Groundwater Transfer Review Summary Form

Transfer/PA # T- <u>14014</u>				
GW Reviewer Phillip I. Marcy Date Review Completed: 06/23/2023				
Summary of Same Source Review:				
The proposed change in point of appropriation is not within the same aquifer as per OAR 690-380-2110(2).				
Summary of Injury Review:				
\Box The proposed transfer will result in another, existing water right not receiving previously available water to which it is legally entitled or result in significant interference with a surface water source as per 690-380-0100(3).				
Summary of GW-SW Transfer Similarity Review:				
☐ The proposed SW-GW transfer doesn't meet the definition of "similarly" as per OAR 690-380-2130.				
This is only a summary. Documentation is attached and should be read thoroughly to understand the basis for determinations.

Oregon Water Resources Department ◯ Water Right Transfer 725 Summer Street NE, Suite A Salem, Oregon 97301-1271 ☐ Permit Amendment (503) 986-0900 ☐ GR Modification www.wrd.state.or.us ☐ Other Application: T-14014 Applicant Name: Kenneth Hendricks/Hendricks Farms Inc. ⊠ POA \square APOA \square SW \rightarrow GW \square RA Proposed Changes: \square USE □ POU \square

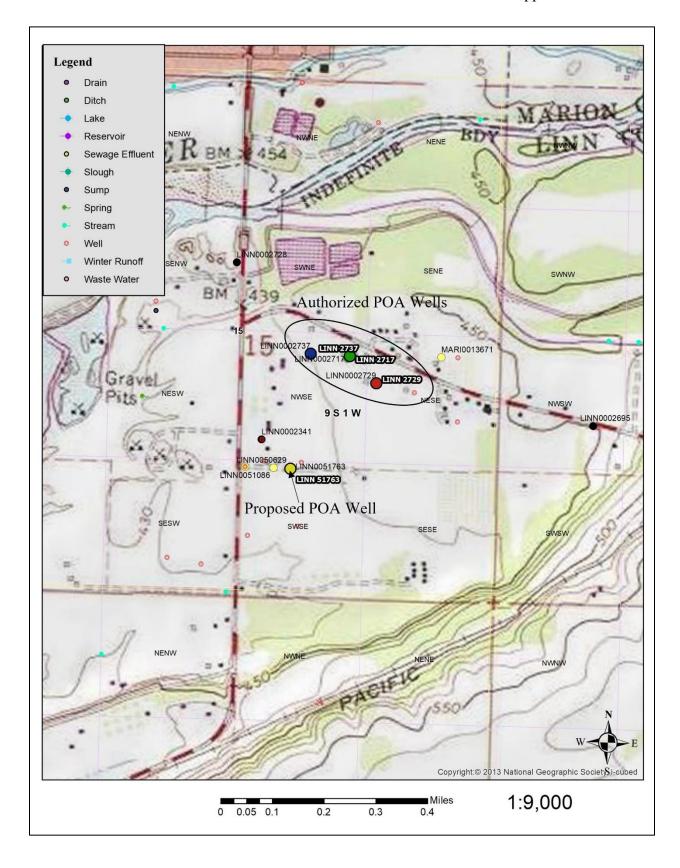
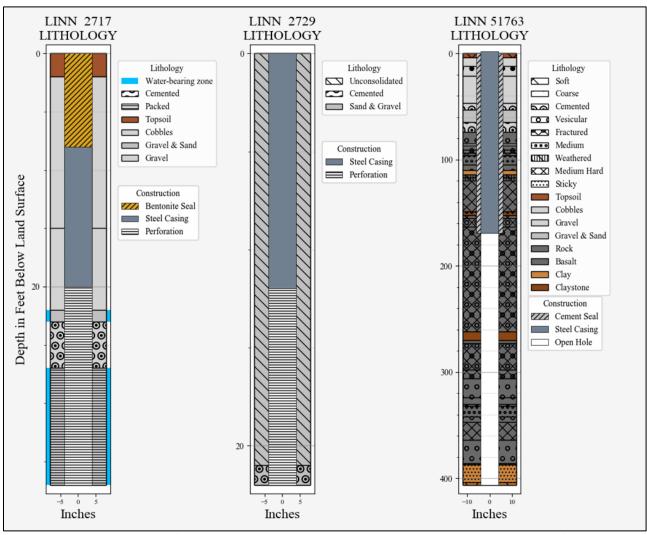
- 7. What conditions or other changes in the application are necessary to address any potential issues identified above: <u>NA</u>
- 8. Any additional comments: <u>The proposed POA well produces from a distinctly different aquifer system than the previously authorized POA wells under the certificate water rights listed above.</u>

The depth and construction of the three authorized POA wells (two shown above) versus that of the proposed POA well (at right) are vastly different and designed to produce from different aquifer systems.
